**AVIUM DA Variation Access
Review - S4.55 DRAFT**

**MATER MARIA COLLEGE
5 FOREST ROAD, WARRIEWOOD NSW**

**DA Variation Access
Review - S4.55
FINAL**

18 June 2019

PLAN DETAIL of ADDITIONAL PARKING SPACES (3 X ACCESSIBLE SPACES)

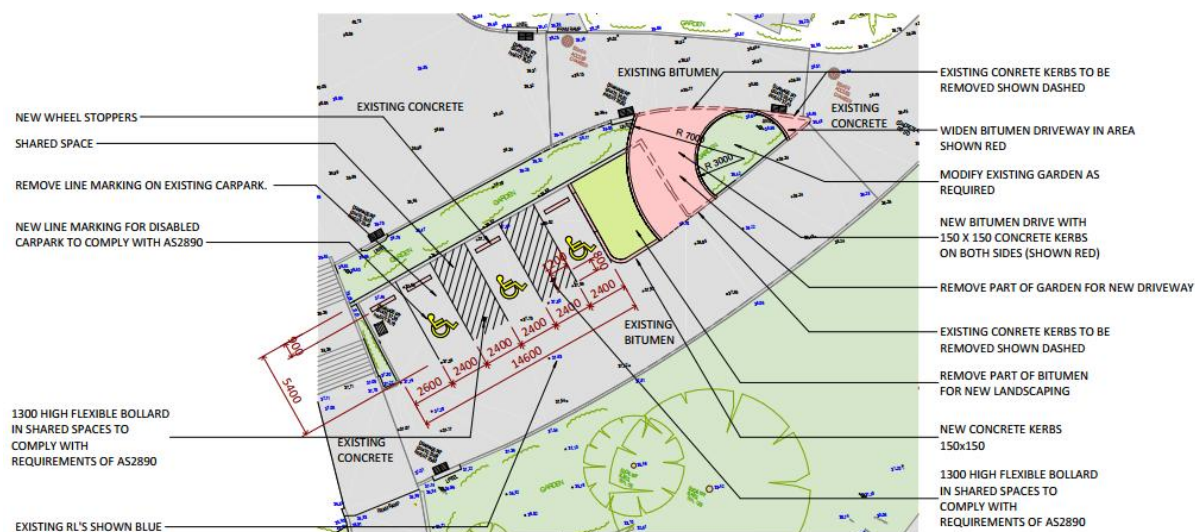
MGAC has reviewed the drawings and documentation in relation to the aforementioned requirements. On the basis of the current level of detail all access requirements appear capable of achieving compliance. The accessible path of travel from the dedicated accessible parking to the entrances of the new building is to be achieved and maintained as per MGAC report for DA-2006/1698/C.

Further work will be required during design development stage to ensure appropriate outcomes are achieved – including the *Traffic & Parking Management Plan (TPMP)* as identified in the *Traffic Impact Assessment* by Cardno and dated 6 February 2019.

Refer to drawings and comments below:

PLAN DETAIL of THE ADDITIONAL PARKING SPACES (NO ACCESSIBLE SPACES)
